PLANNING AND DEVELOPMENT SERVICES STAFF REPORT

For Planning Commission Meeting of May 20, 2014

**SUBJECT: Bank of Ann Arbor Headquarters Addition Special Exception Use and Site Plan for City Council Approval
(125 South Fifth Avenue)
Project Nos. SP14-015 and SEU14-008**

SHEET + NUMBER
A5.00

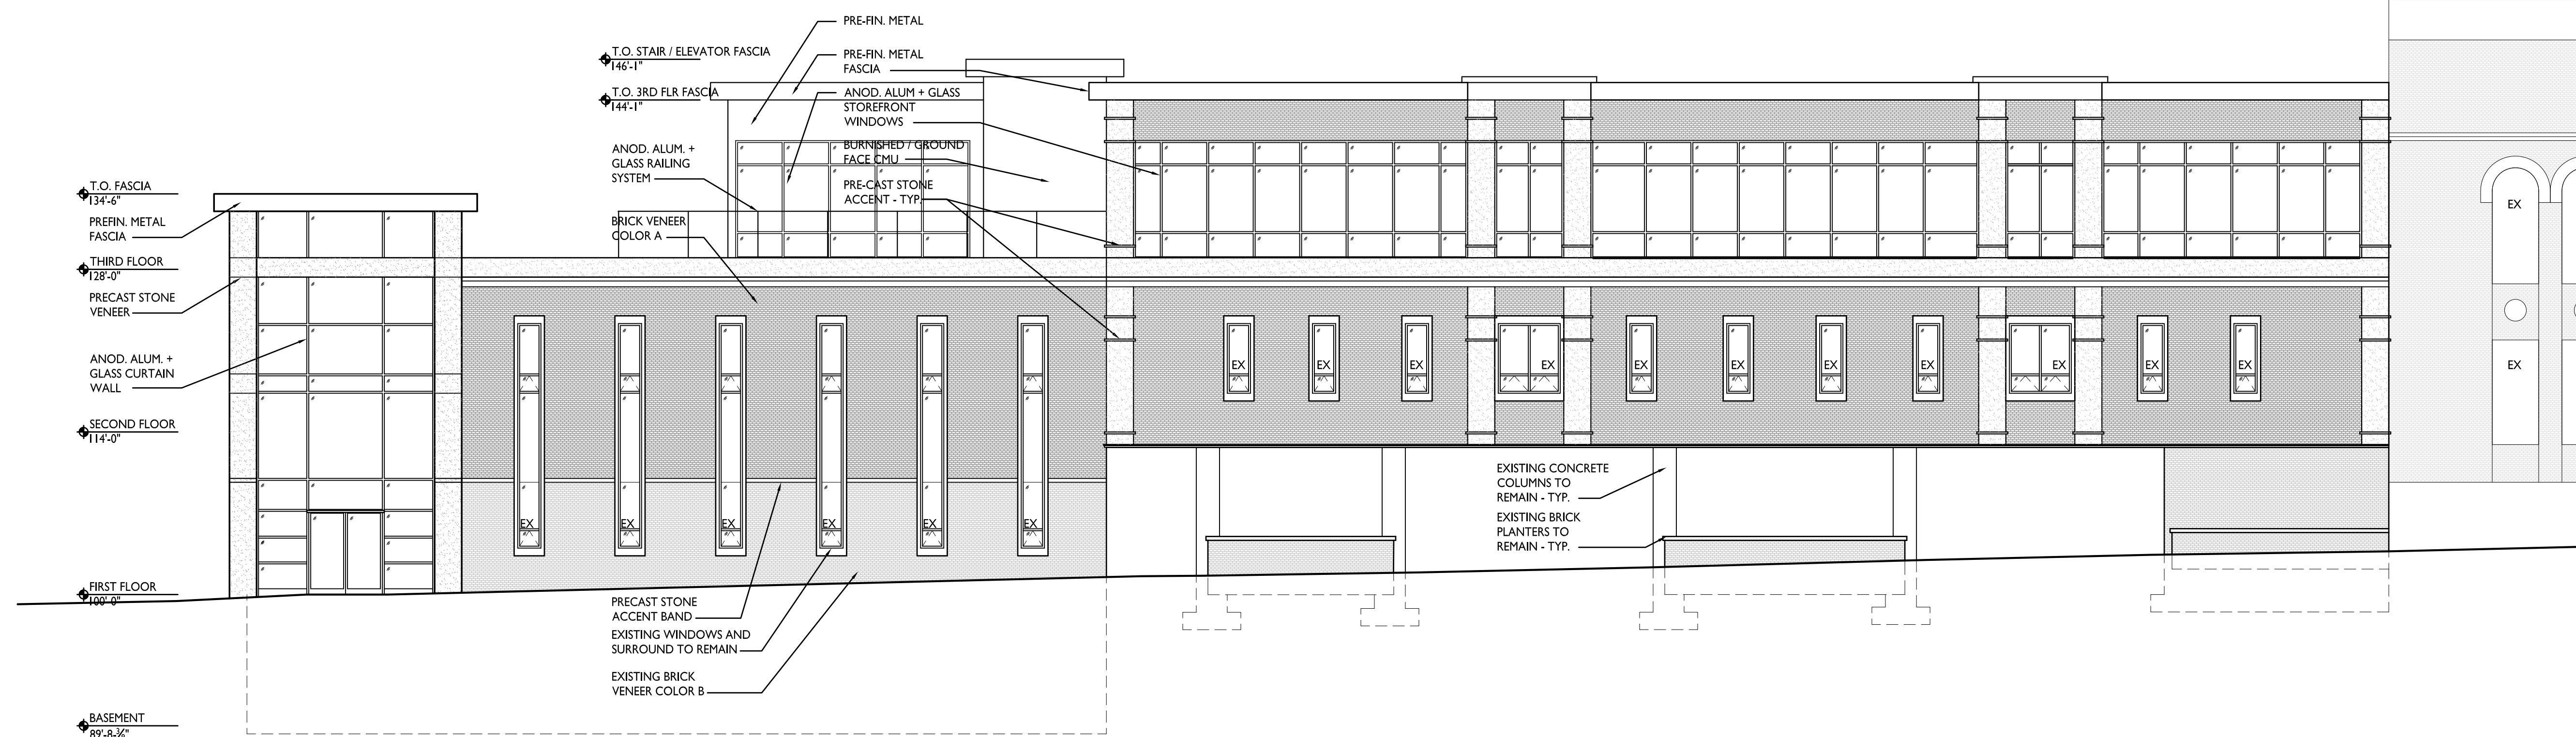
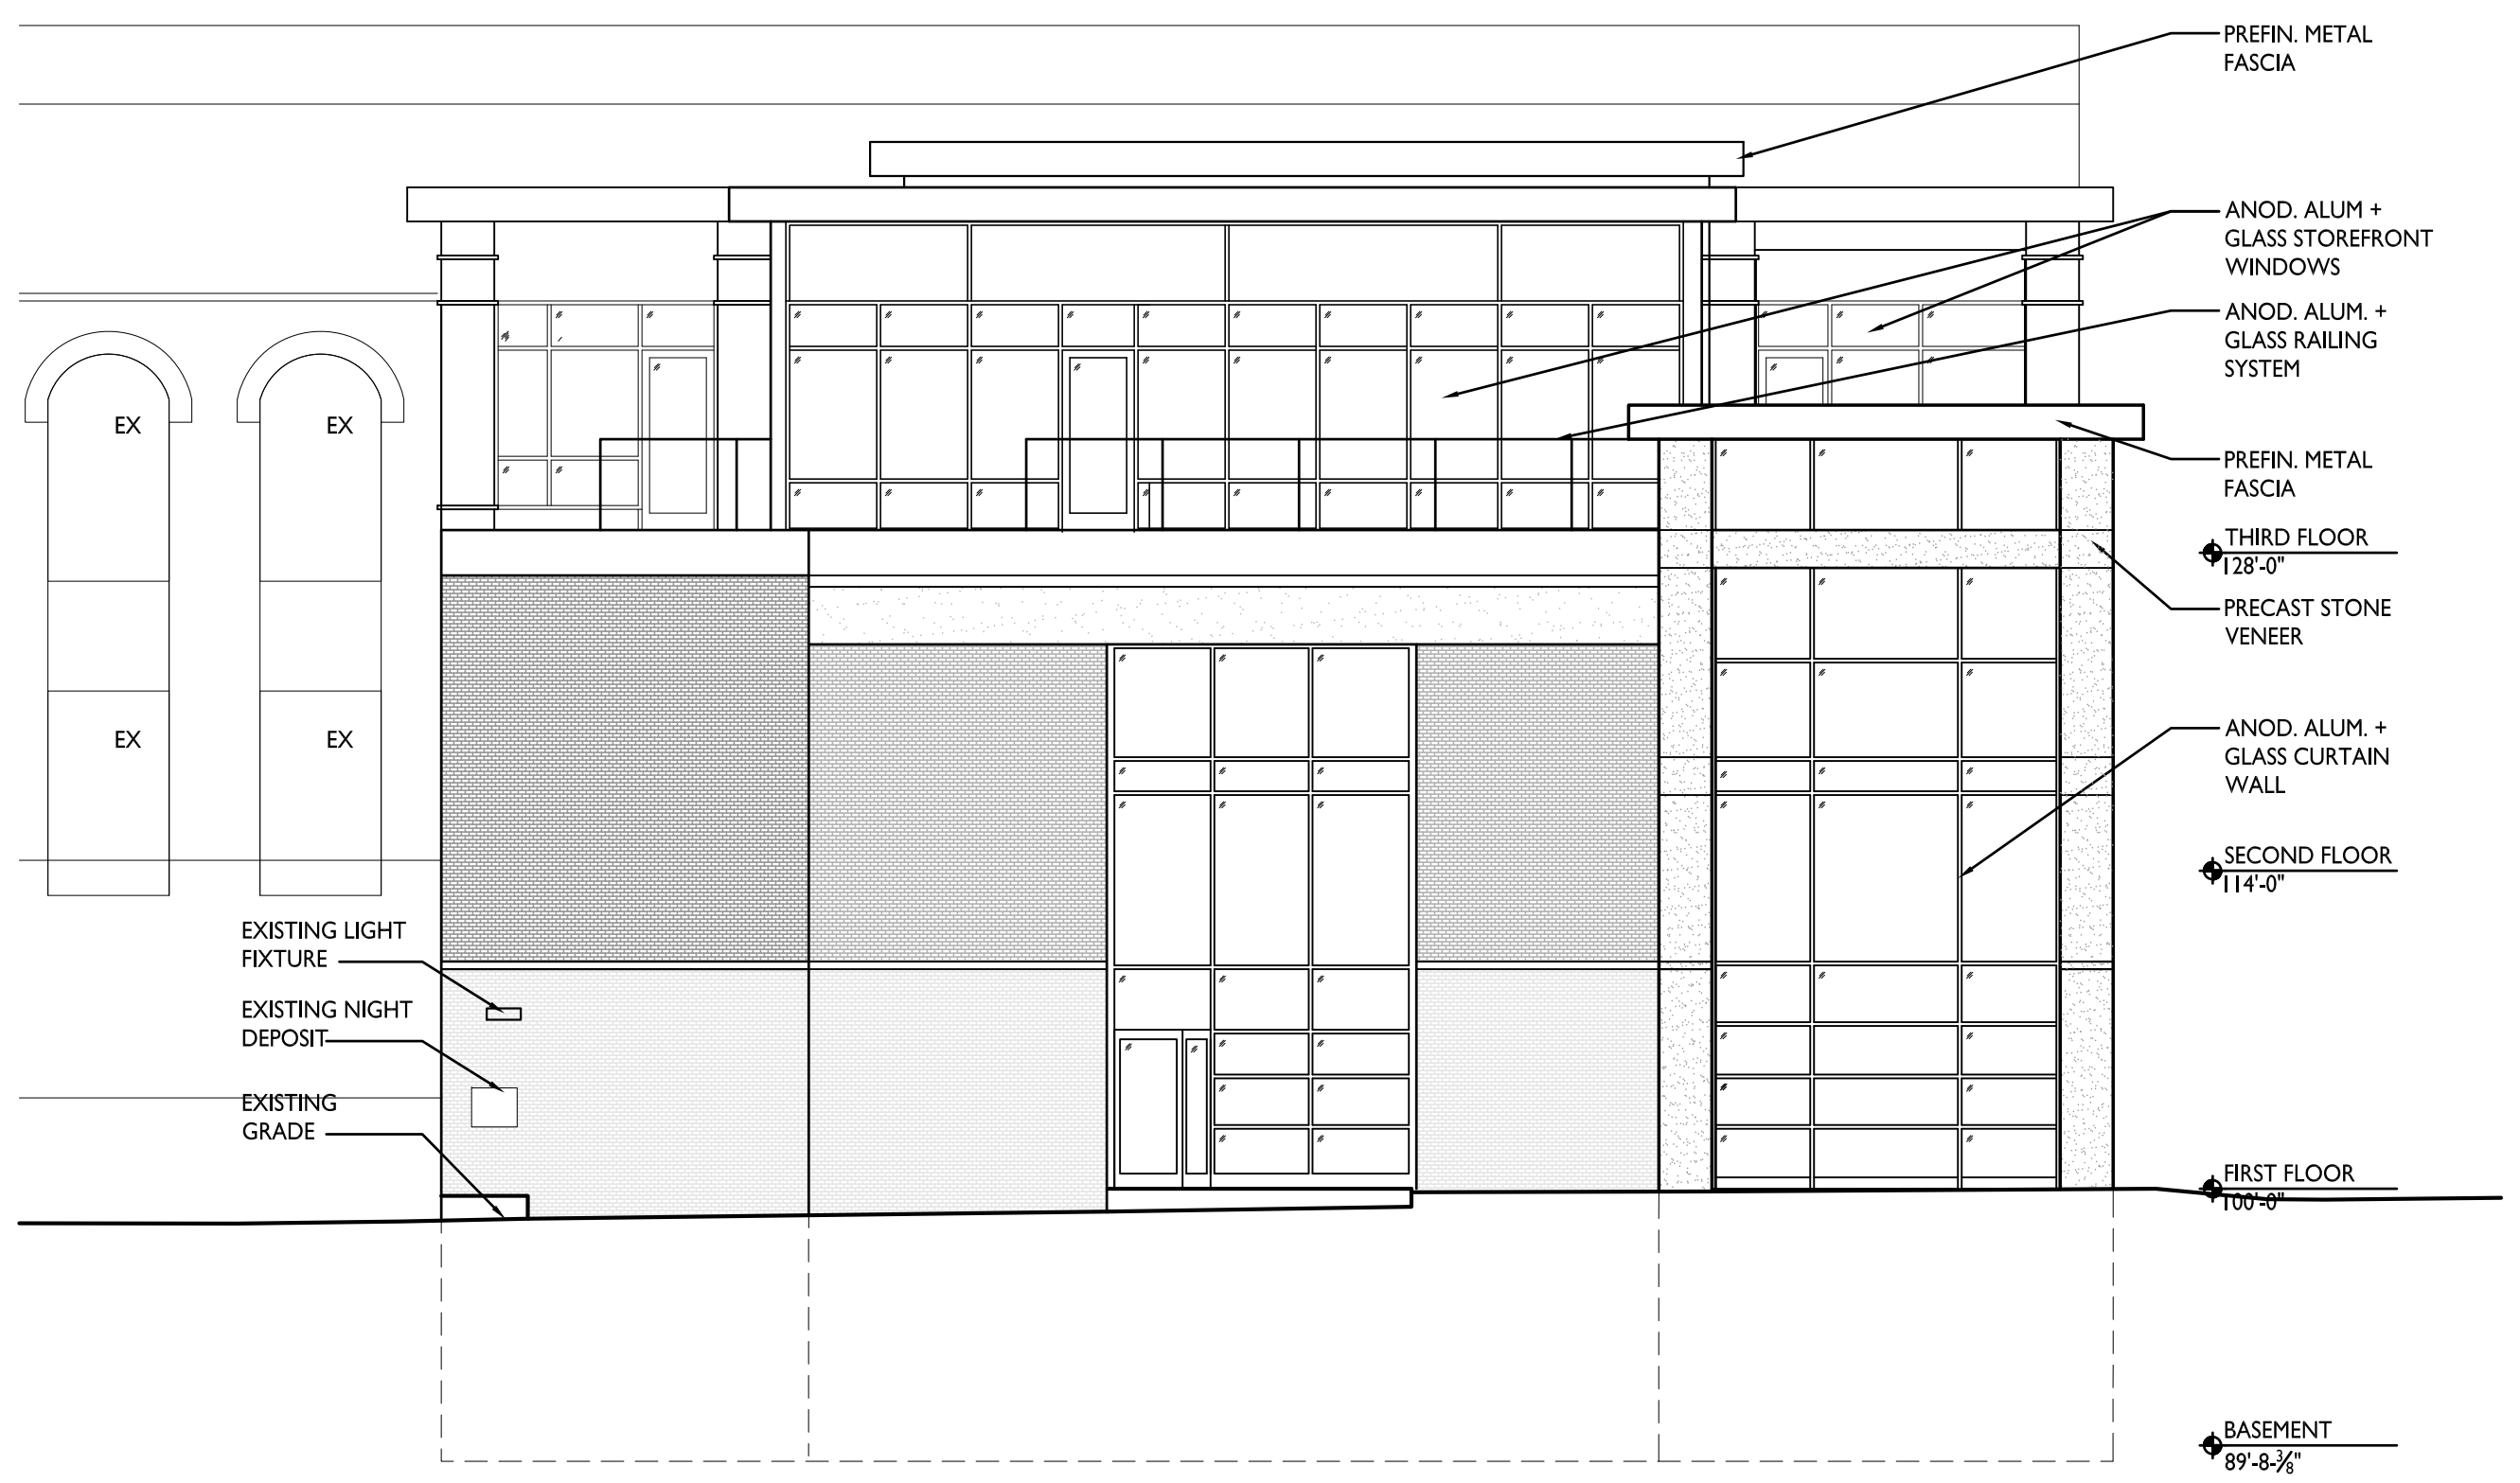
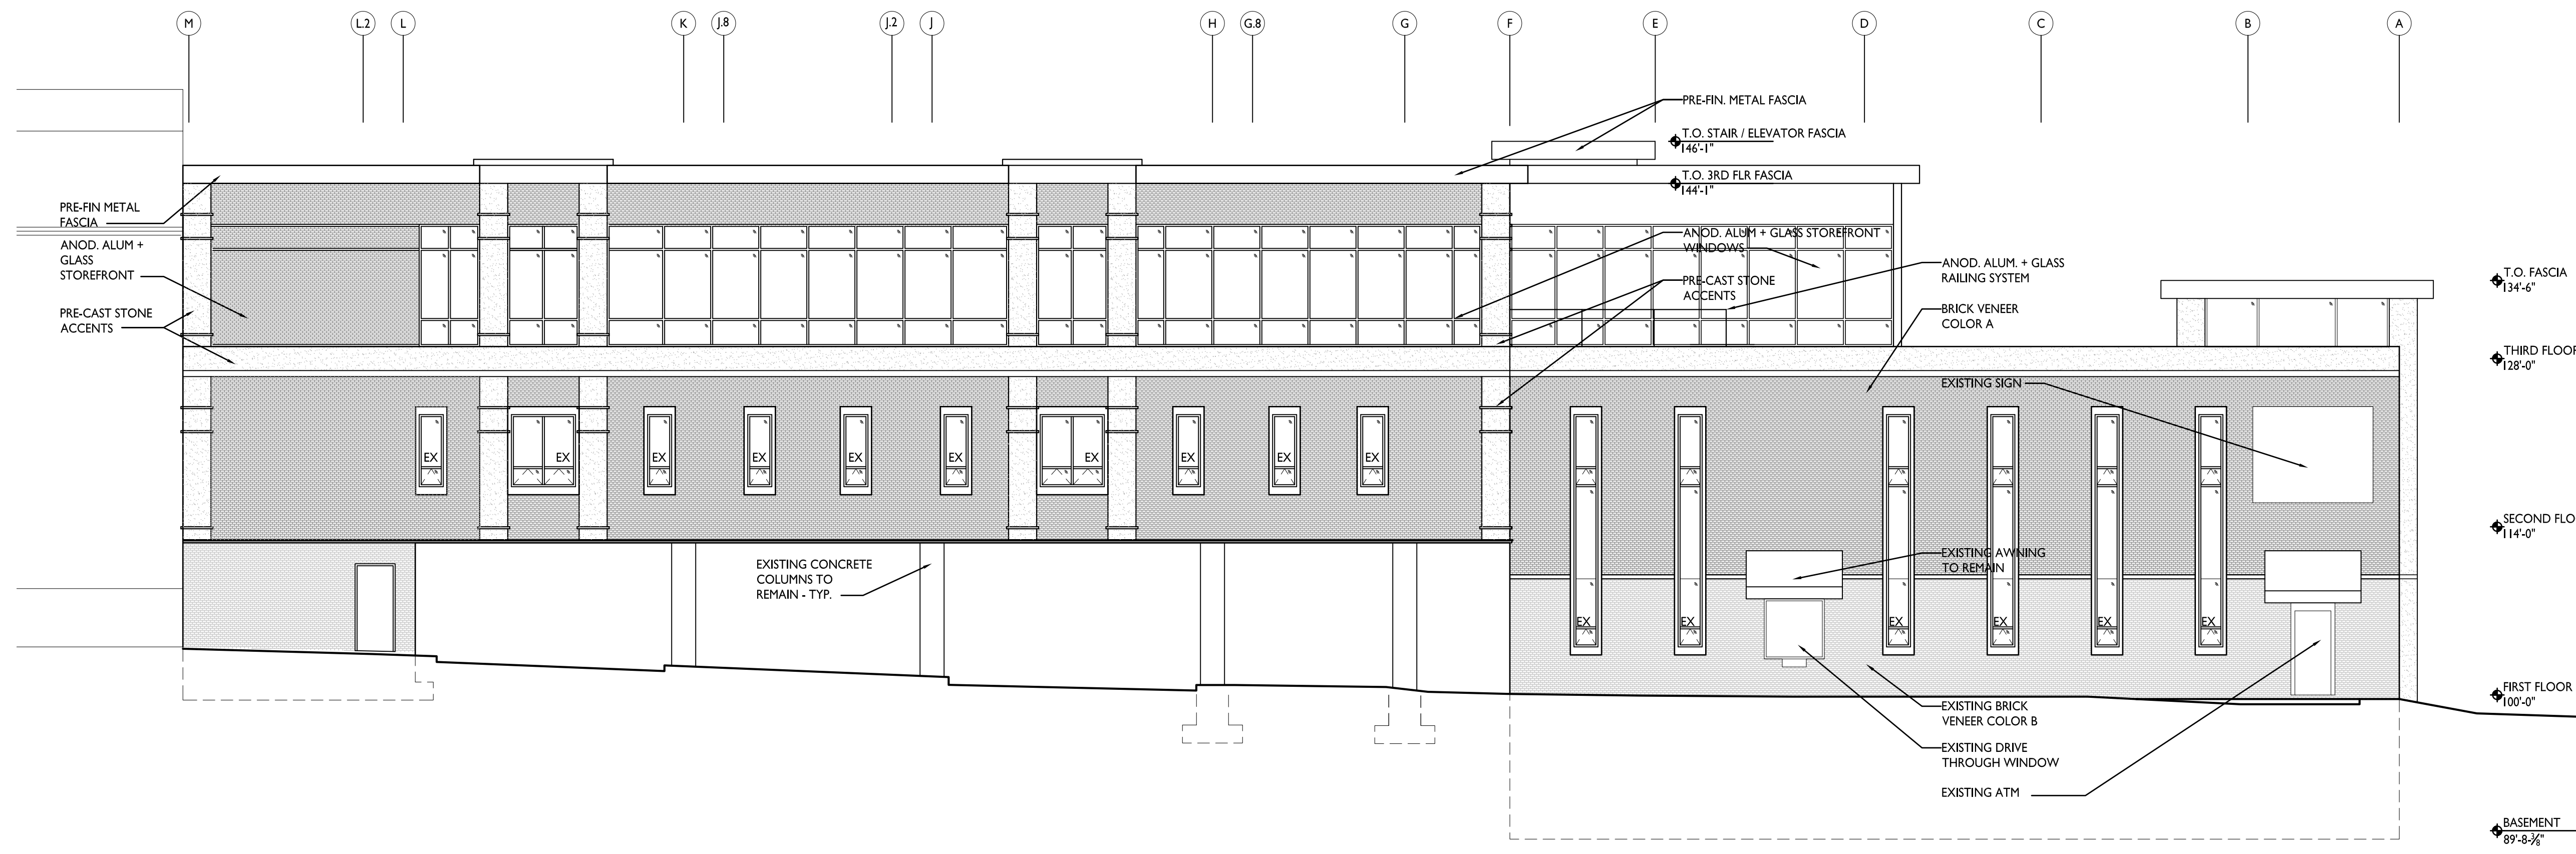
1. The new entry structure at the southwest corner of the building is appropriately placed but could be made even taller for better proportion with the rest of the building. (B.1.1)

1. The new entry structure at the southwest corner of the building is appropriately placed but could be made even taller for better proportion with the rest of the building. (B.1.1)
The new entry proportions have been reviewed by Bowers + Associates. The entry is now taller than originally presented to the Design Review Board.
